Access Compliance Report Public Rights-of-Way (Curb Ramps)

Main Street: ARROYO_AVE Cross Street: ARROYO_LINDO_DR Location: SE

ADA ID: RPAT220225165135 Ramp Type: Type 4 - Parallel Initial Pass/Fail: Pass Overall Compliance: No Severity Score: 6

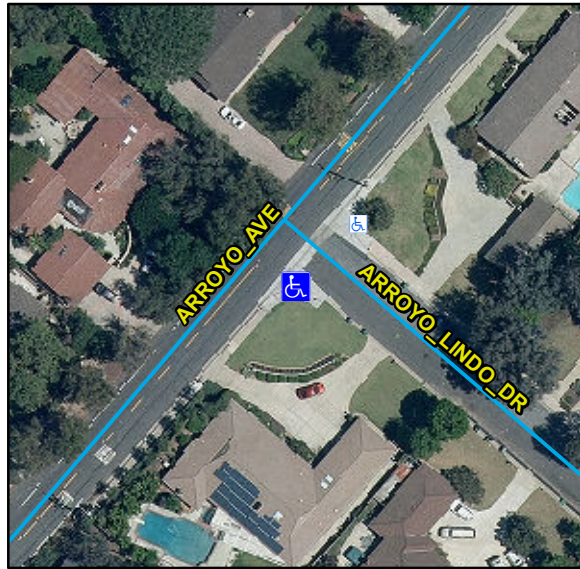
Compliance	Description	Data	Compliance	Description	Data
N/A	Ramp Length LT (in)	105	N/A	Ramp Length RT (in)	100
Yes	Ramp Width LT (in)	57	Yes	Ramp Width RT (in)	57
Yes	Ramp Run Slope LT (%)	7.1	Yes	Ramp Run Slope RT (%)	4.3
No	Ramp Cross Slope LT (%)	2.6	Yes	Ramp Cross Slope RT (%)	1.3
N/A	Landing Present	Yes	Yes	DWS Provided	Yes
N/A	Landing Length (in)	57	Yes	DWS Contrast	Yes
Yes	Landing Width (in)	48	Yes	DWS Length (in)	36
Yes	Landing Run Slope (%)	1.1	Yes	DWS Full Width	Yes
Yes	Landing Cross Slope (%)	1.6		DWS Offset Type	Single
N/A	Landing Movement Obstructed?	Yes	Yes	DWS Offset Left (in)	2
	Landing Movement Type	Curb	Yes	DWS Offset Right (in)	N/A
N/A	Landing Shared	No			
N/A	Clear Space	Yes			
N/A	Clear Space To Crosswalk (in)	48			
N/A	Marked Crosswalk 1	No	N/A	Marked Crosswalk 2	No
	Crossing 1 Direction	N		Crossing 2 Direction	E
	Marked Crosswalk 1 Width (in)	N/A		Marked Crosswalk 2 Width (in)	N/A
N/A	Ramp Inside Crosswalk 1	N/A	N/A	Ramp Inside Crosswalk 2	N/A

Crossing 1 Slope (%)	0.8		Crossing 2 Slope (%)	2.6
	Crossing 1 Cross Slope (%)	4.7		Crossing 2 Cross Slope (%)	8
Yes	Gutter Ponding	No	N/A	Curb Slope	2.6
Yes	Gutter Lip Height (in)	0		Road Run Slope (%)	3.6
No	Gutter Run Slope (%)	6.5		Road Cross Slope (%)	1.4
Yes	Gutter Cross Slope (%)	1.8	Yes	Perpendicular Joint Present	Yes
Yes	Overall Surface Condition	Acceptable			
	Cross Gutter Present?	Yes		Spandrel Present?	Yes
	Replace Cross Gutter?	No		Replace Spandrel?	No

Remove & Replace Curb Ramp With Two New Directional Ramps or Equivalent. Remove & Replace Gutter.

R304.5.3, R304.2.1, R304.5.4, STD 1115
